This is in response to the questions that the Middletown Corridor Coalition has raised in response to the May 16, 2007 Presentation. The answers are broken down as follows:

Mark Tudor  
DeIDOT  
US301 Project Director

#### **QUESTIONS FROM MAY 16<sup>TH</sup>, 2007 MEETING AT MS. DALEY'S HOUSE**

Delaware Department of Transportation	US 301 Project Development
	DRAFT ENVIRONMENTAL IMPACT STATEMENT
Typical Sections for US 301	
November 2006	Figure 11-4

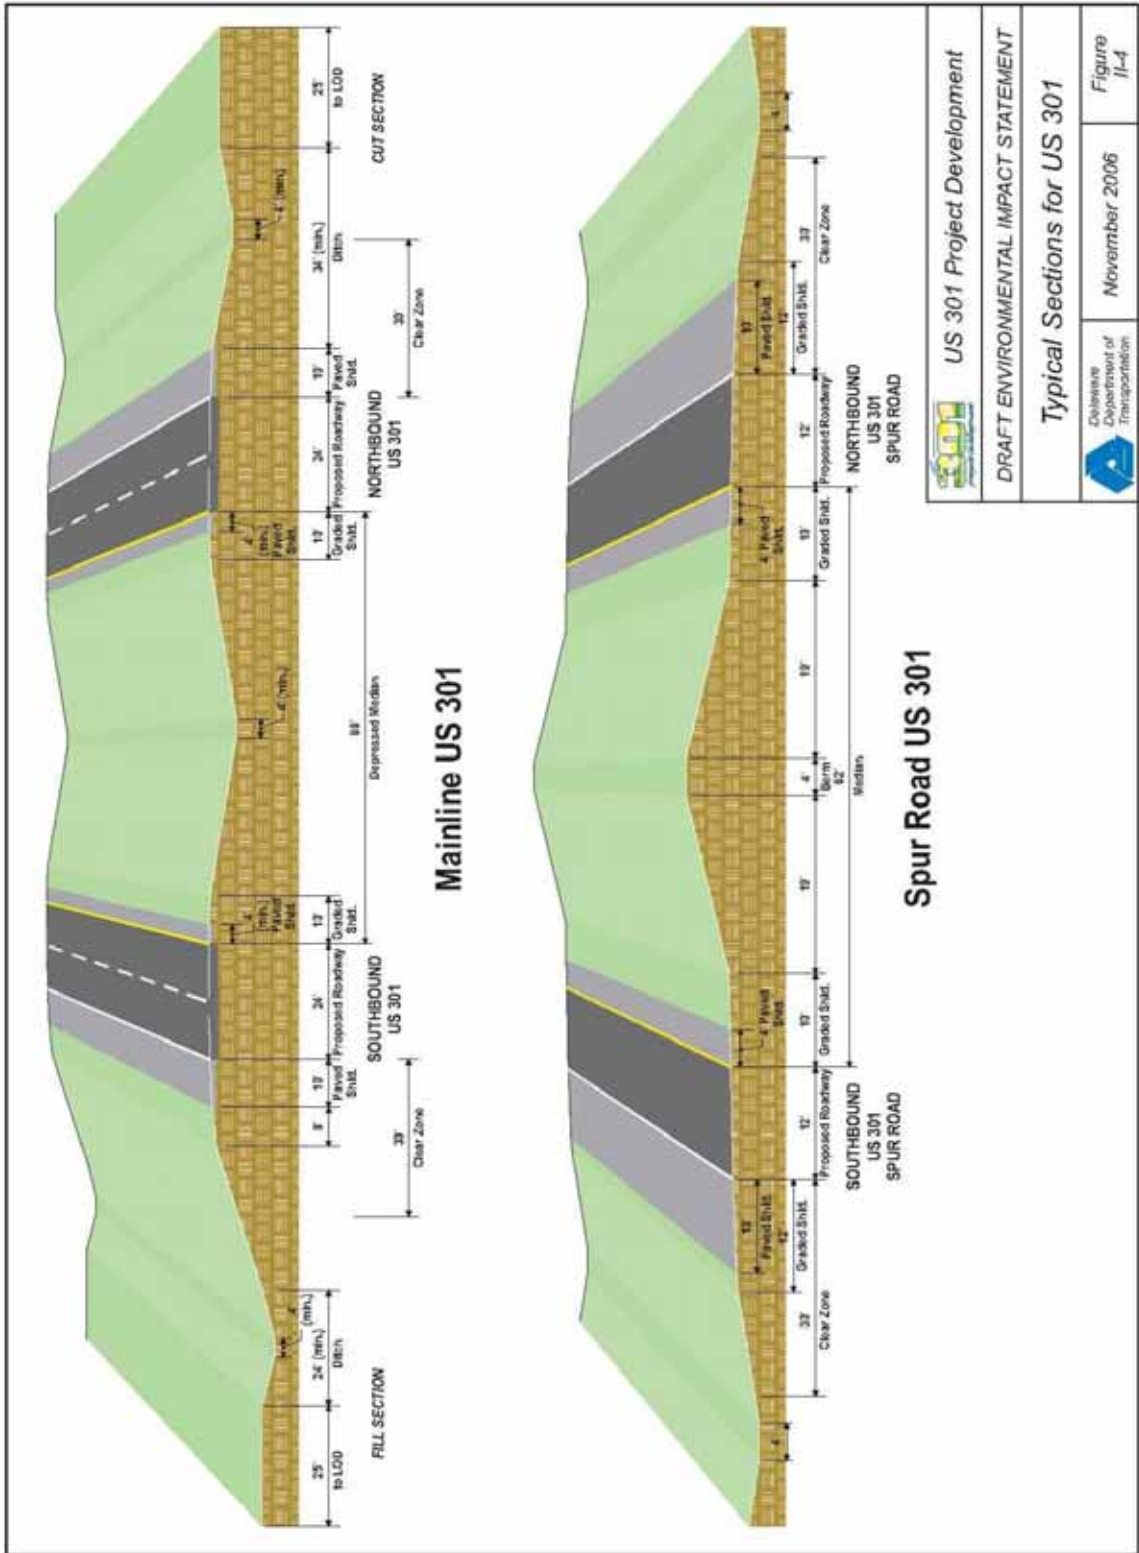
➤ **Design of the Spur Road is poor at best and needs much more thought.**

- The Spur Road, as currently proposed, has been developed in accordance with DeIDOT design standards.
- See attached typical sections of the Spur Road, taken from DEIS Figure II-4.
- The Coalition needs to provide more detail regarding this comment.
